**From:** John Wilkins <jwilkins@cityofkeywest-fl.gov>  
**Sent:** Tuesday, February 26, 2019 10:54 AM  
**To:** Owen Trepanier  
**Subject:** FW: 1028 - 1030 Truman Ave.

**From:** John Wilkins  
**Sent:** Monday, February 25, 2019 5:03 PM  
**To:** James K. Scholl <jscholl@cityofkeywest-fl.gov>; Greg Veliz <gveliz@cityofkeywest-fl.gov>  
**Cc:** Vanessa T. Sellers <vsellers@cityofkeywest-fl.gov>; Patrick Wright <pwright@cityofkeywest-fl.gov>  
**Subject:** 1028 - 1030 Truman Ave.

I have visited this site to collect data and give my opinion concerning the impact of a new driveway to on-street parking for the proposed 1028 – 1030 Truman Ave. development.

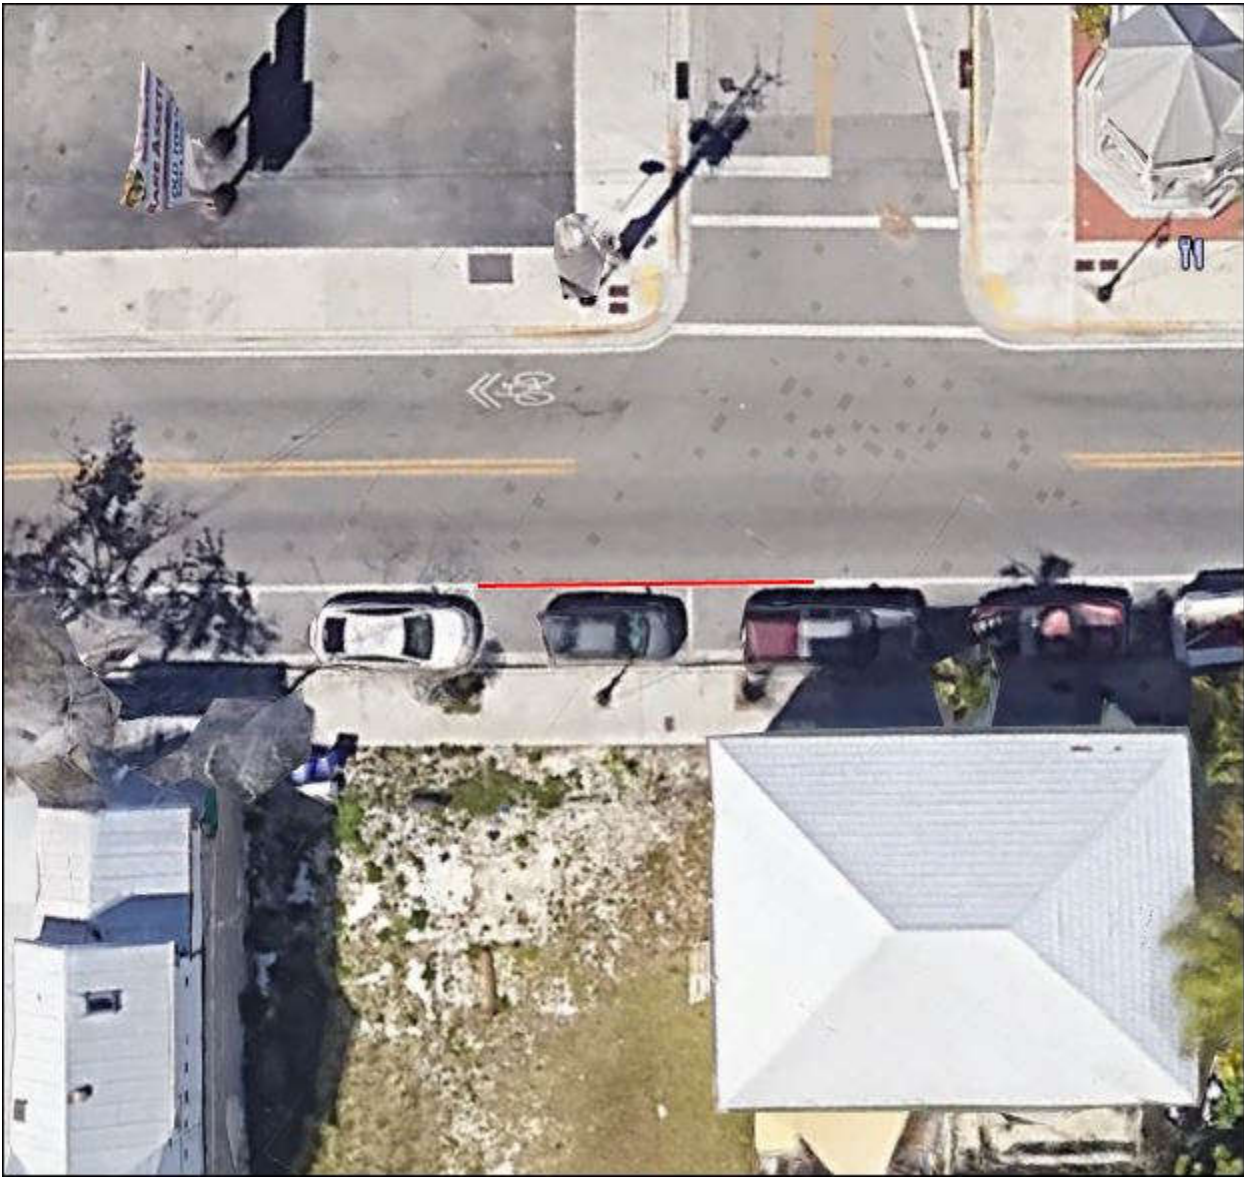
The minimum driveway flare by FDOT Standards is 10 feet either side for driveways of this kind.

The no parking line-of-sight is calculated by traffic engineer based on traffic speed (85 percentile) at the location, width of sidewalk, location of vehicle driver, etc... In this block and next block, the existing minimum no parking line of sight is 18 feet (including 10 foot driveway flare). The maximum no parking line of sight in this area is 25 feet (including 10 foot driveway flare).

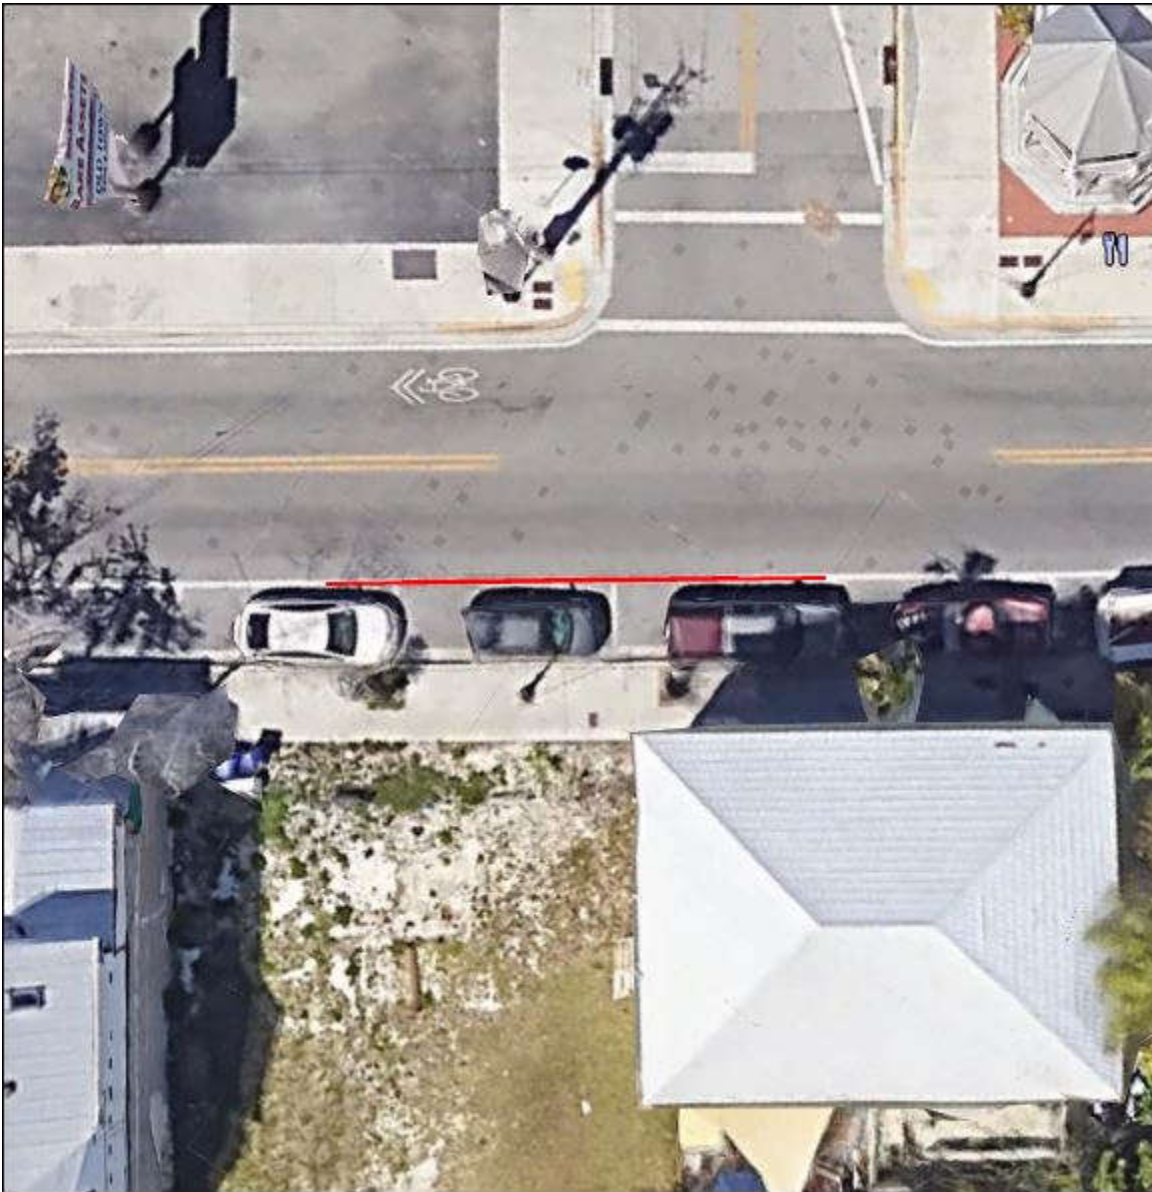
Two parking spaces would be lost on-street if the State only required the 10 foot flare for the no parking line of sight zone.

More likely, three spaces would be lost if they used the 18 feet minimum found in the area for the no parking line-of-sight zone.
